**FINAL**  
**ENVIRONMENTAL IMPACT STATEMENT**

## READER'S GUIDE TO THE DOCUMENT

This is a programmatic environmental impact statement (EIS) for adoption of the proposed Mineral Resource Management Plan (MRMP) for Vandenberg Air Force Base (VAFB).

Figure 7-2

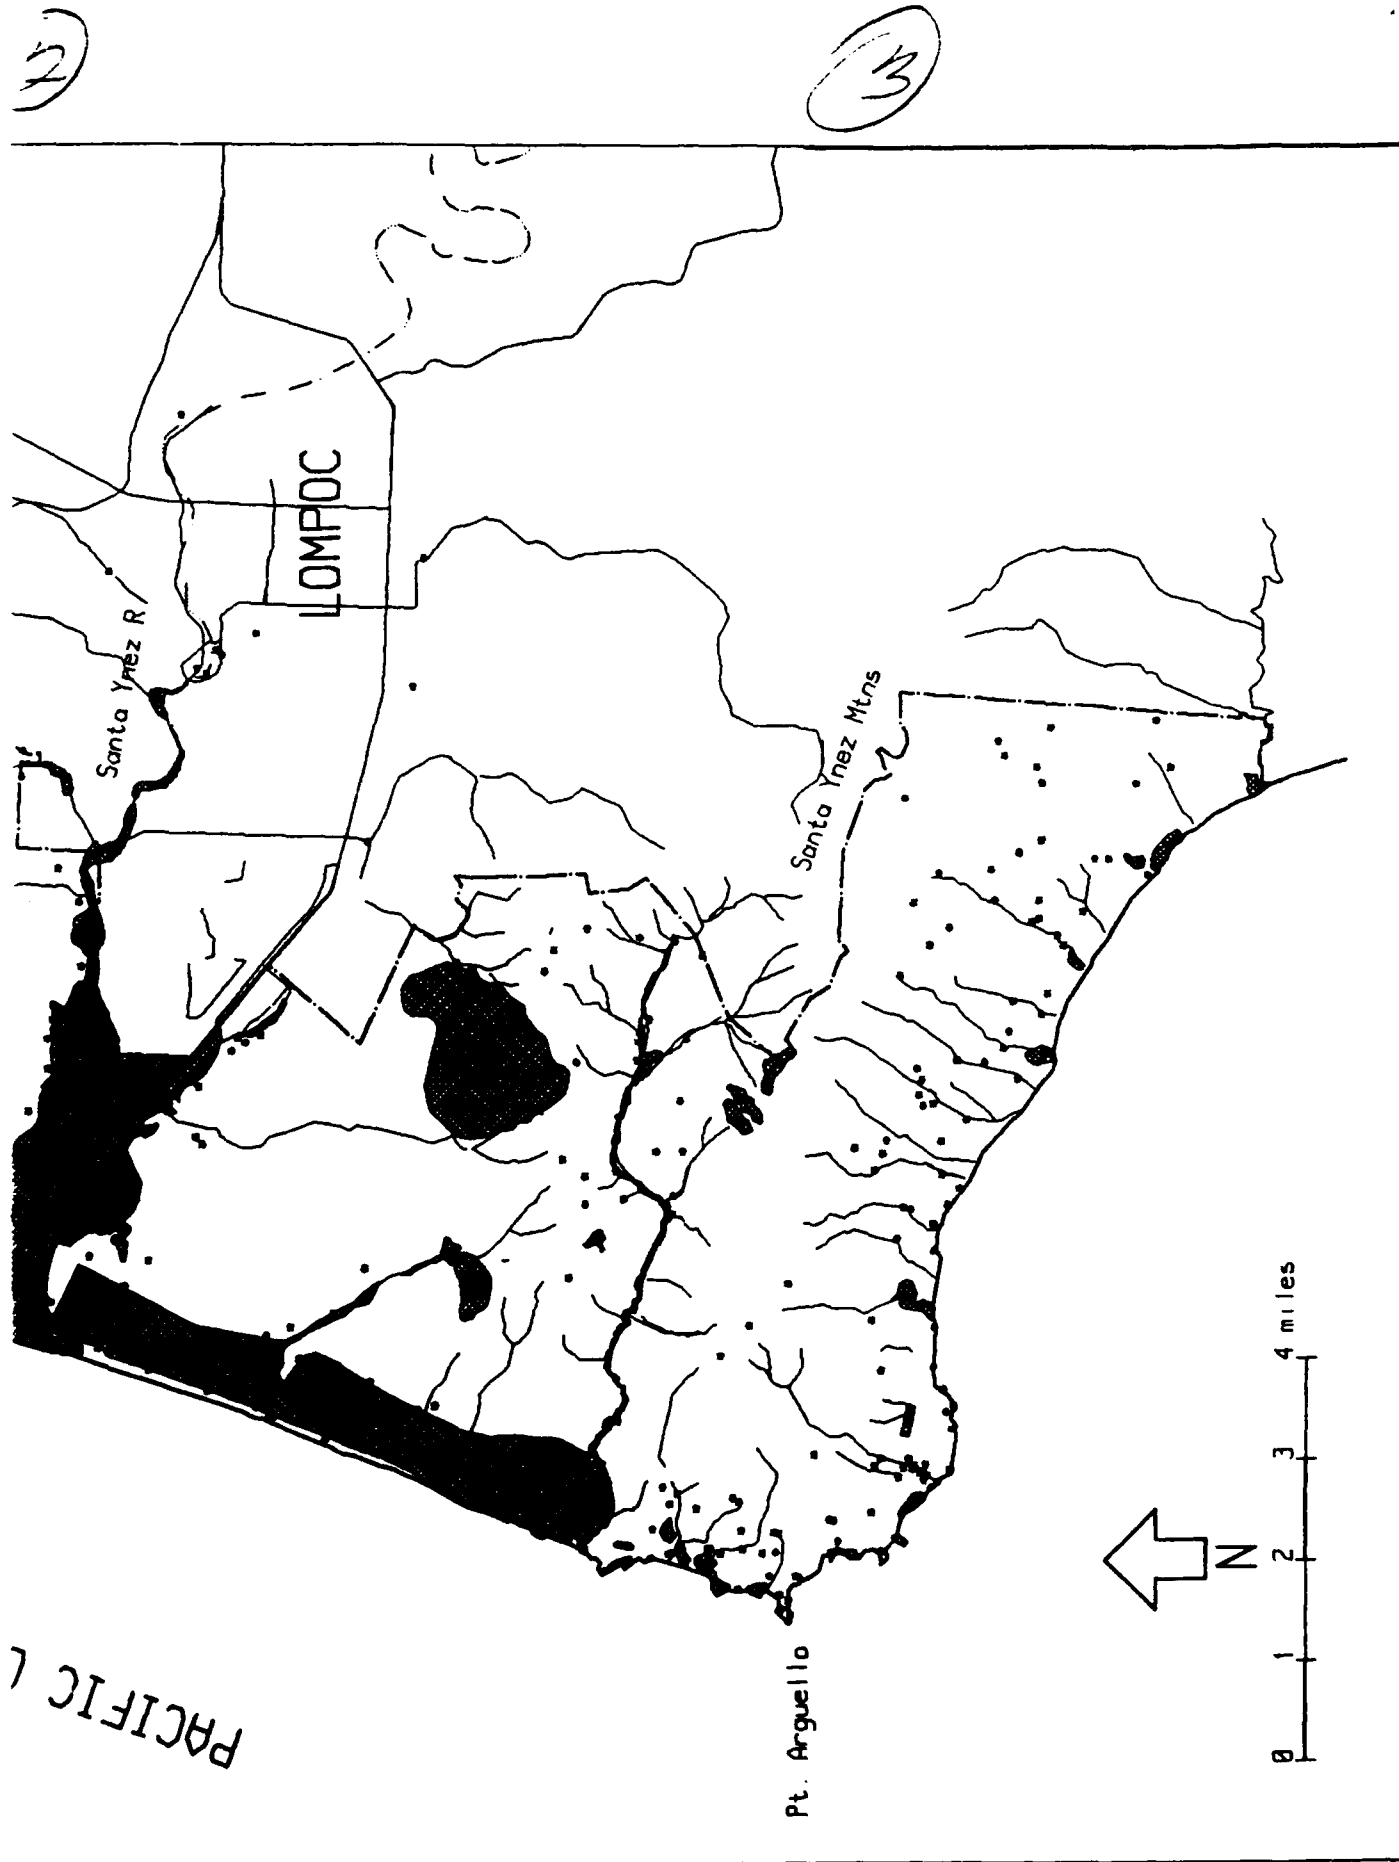
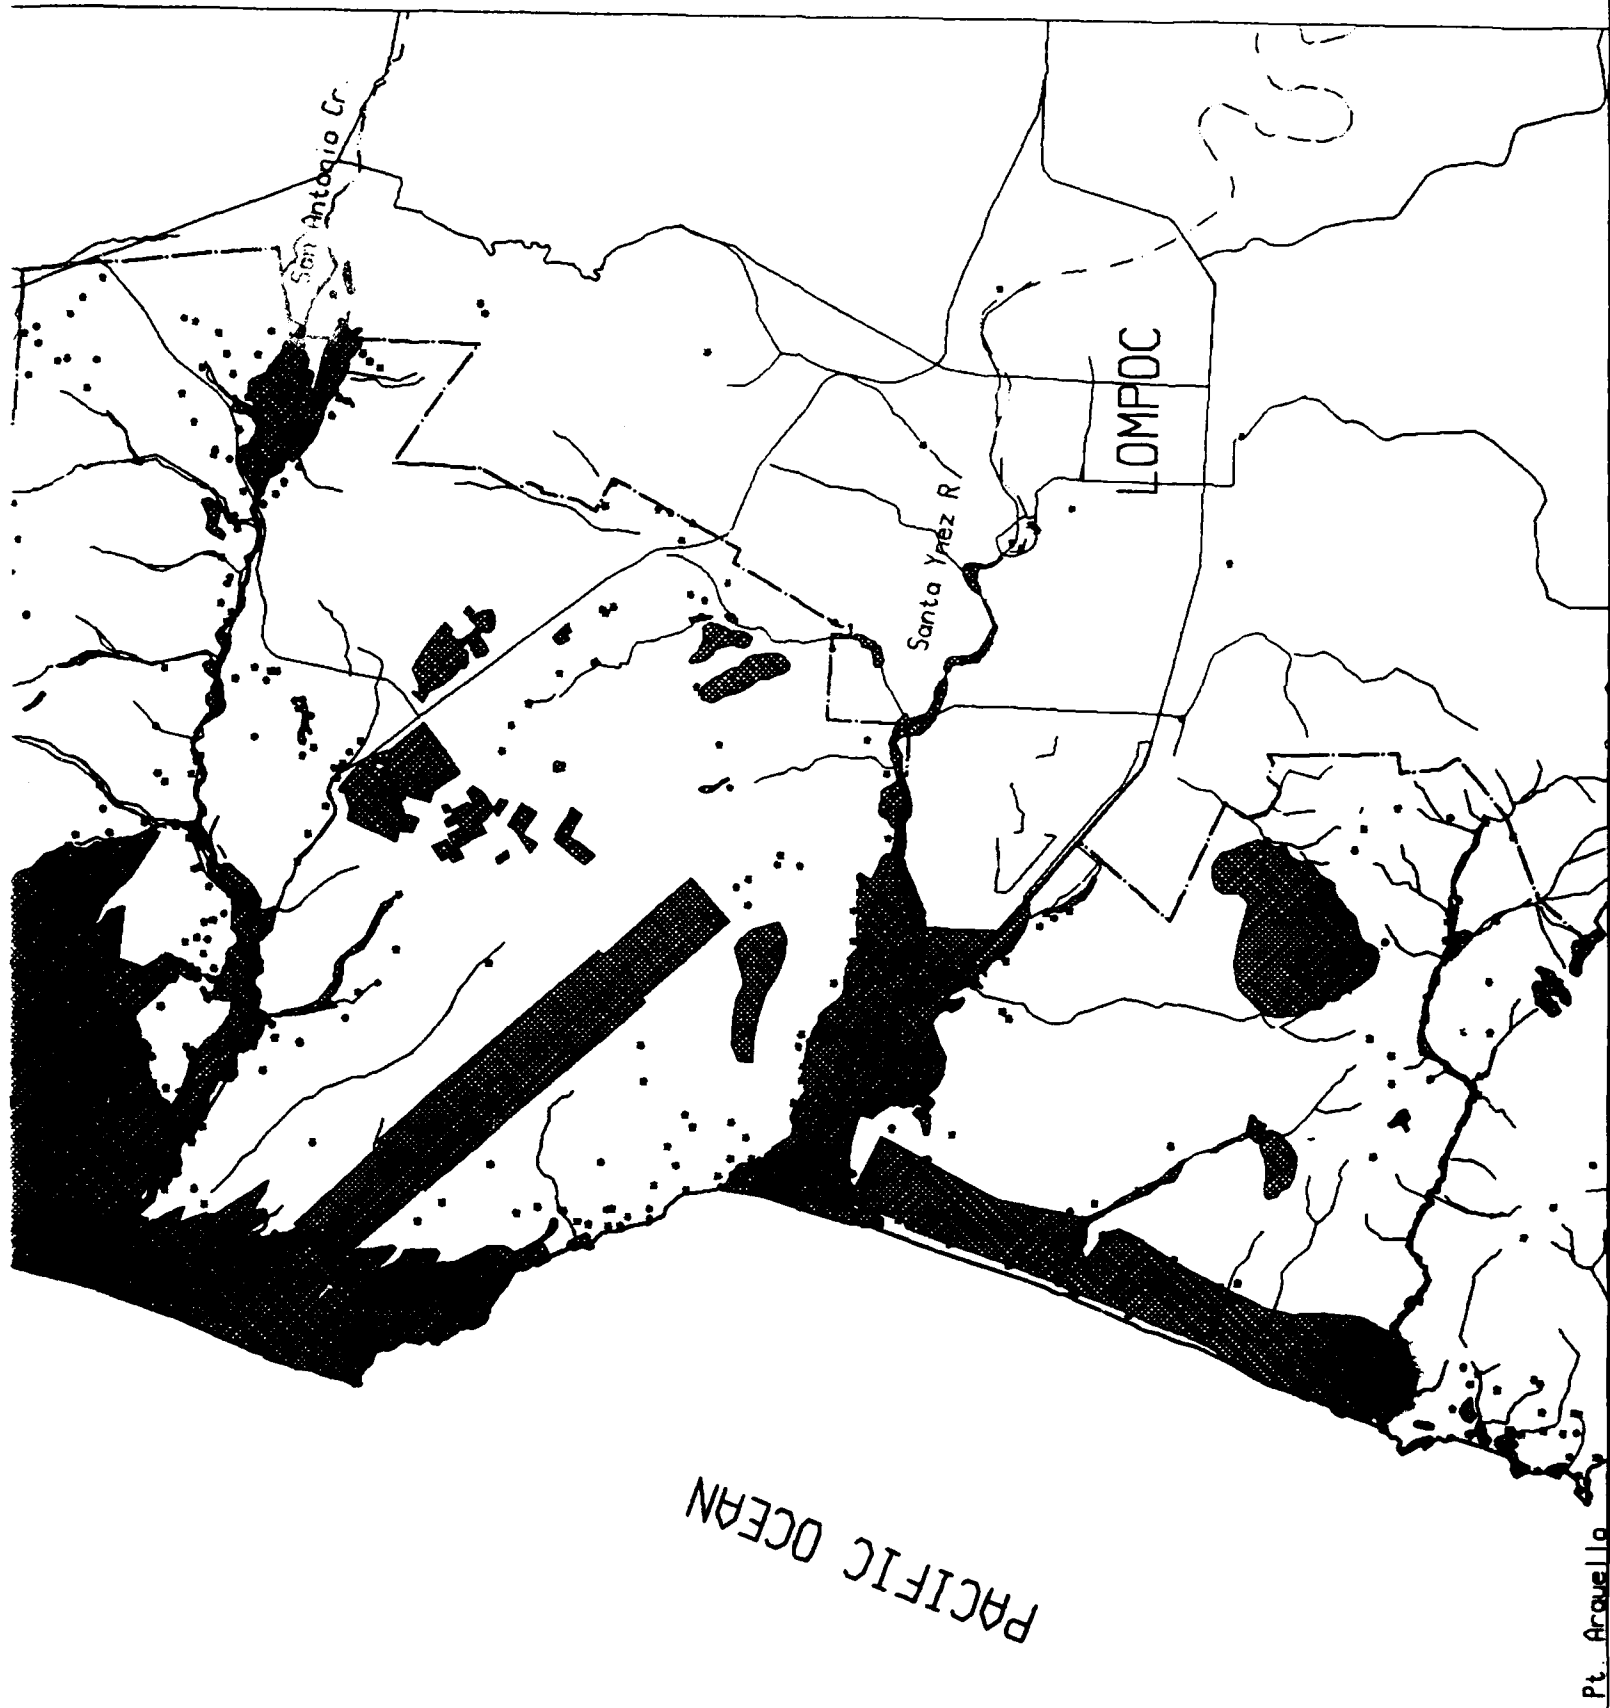
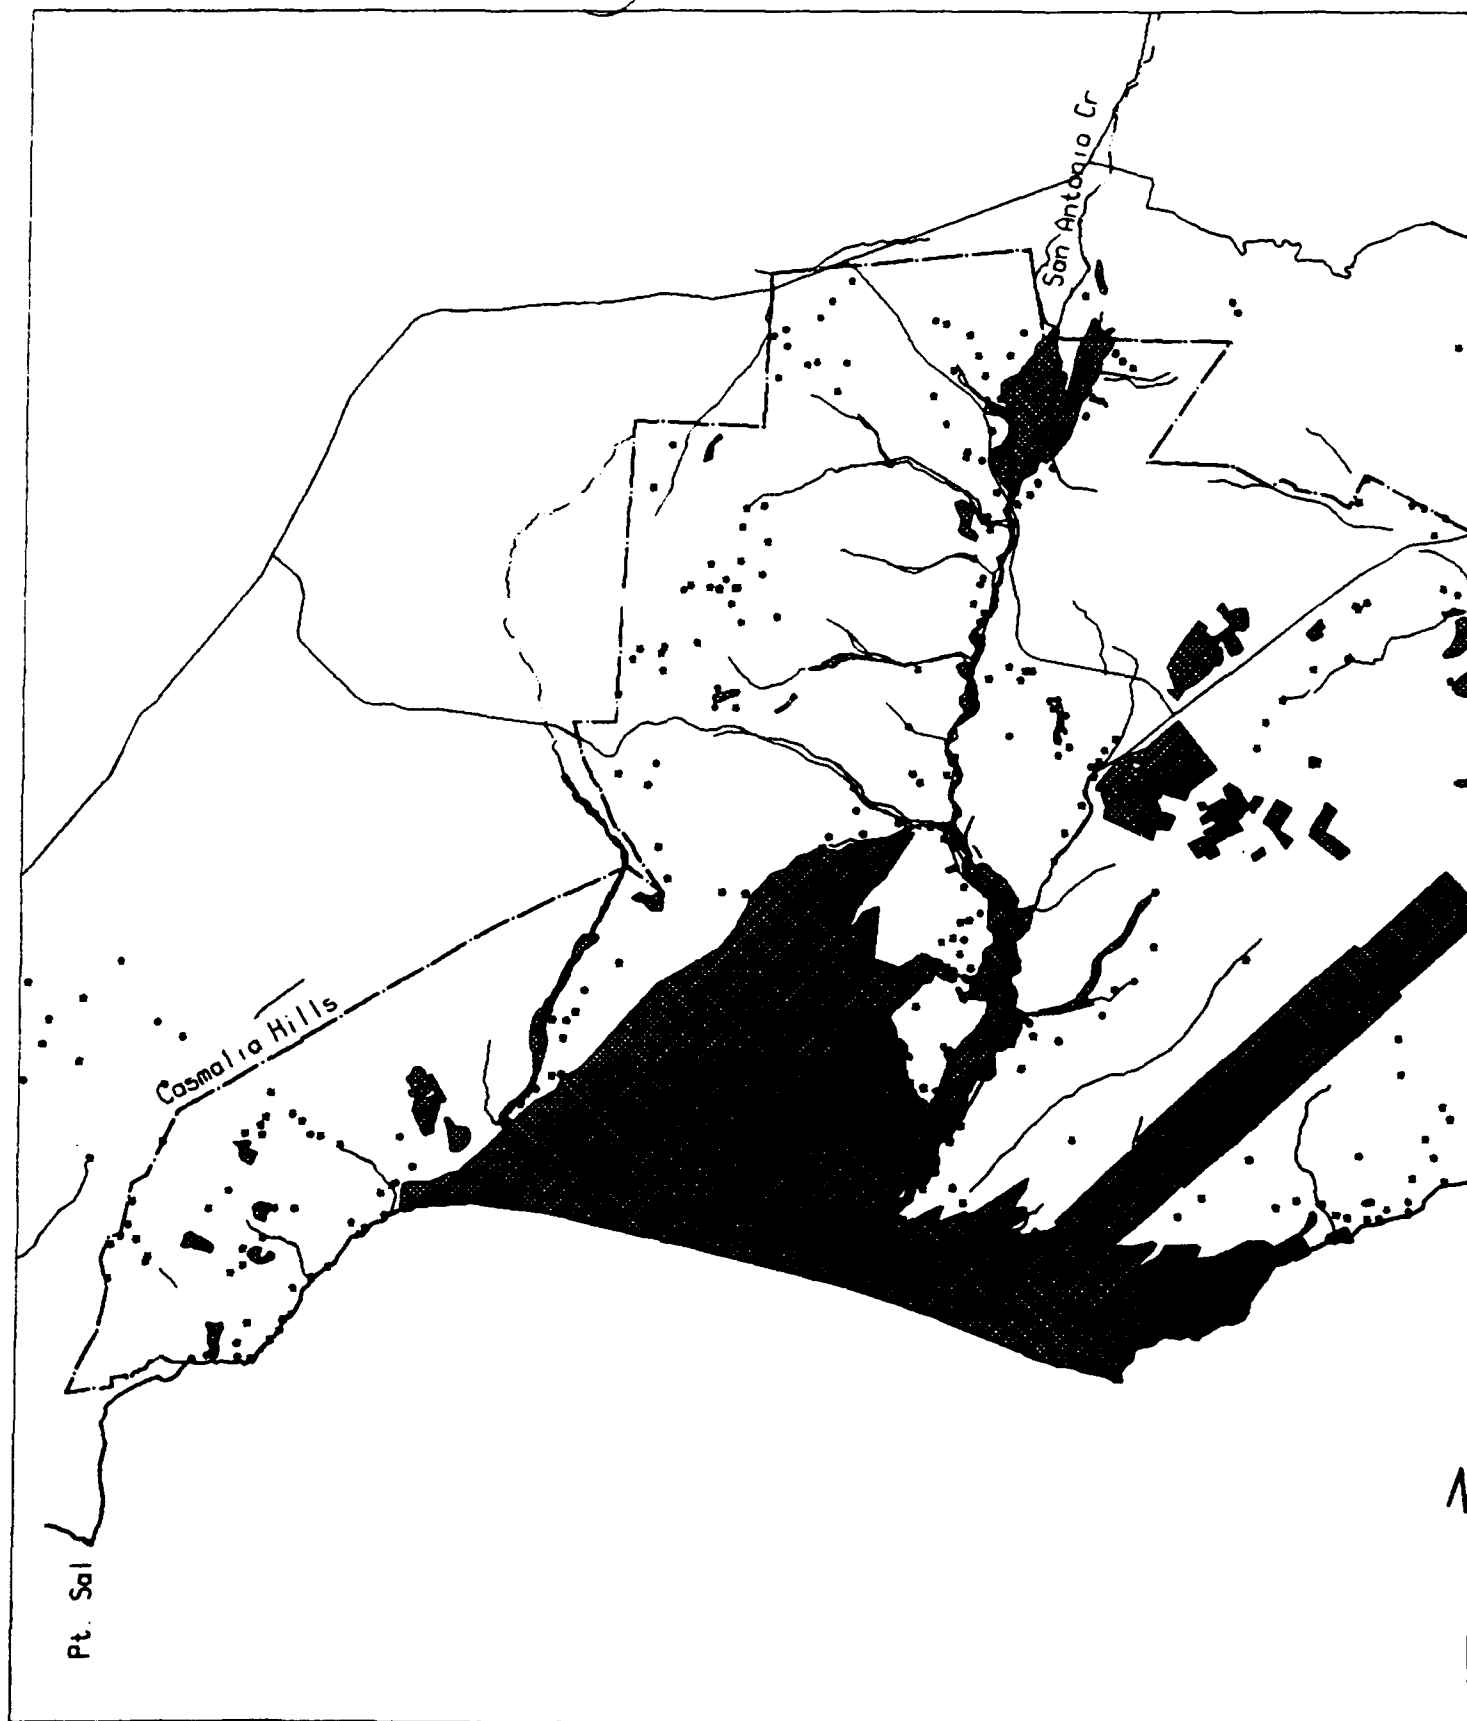
18. Figure 7.2, page 7-7. The LEGEND block is empty; either Legend text must be added, or the block must be removed. Also, this figure should include all lands within the Lompoc and San Antonio Groundwater Basins, since overdrafted groundwater resources are acknowledged in the text as a "high environmental constraint (see e.g. Sec. 6.2.4.1, p. 6.2-21, middle of first full paragraph; Sec. 7.3.3.2, p. 7-6).

- RMD-131      See the response to comment SLC-1.
- RMD-132      The legend is unnecessary and has been deleted from Figure 7-2. Please see the MRMP errata for section 7.0, Plan Criteria and Application. The referenced map gives information on locations of oil and gas facilities which may be constrained by water resource attributes. As noted in the response to comment RMD-83, the location of oil field development is not geographically tied to the location of the water source which would supply the facility. The purpose of this figure is to provide geographic information on constraints of oil and gas development on base.

A legend is unnecessary for Figure 7-2, Composite Environmental High-Constraint Areas, on page 7-7; therefore, the legend inset has been removed. See attached figure.
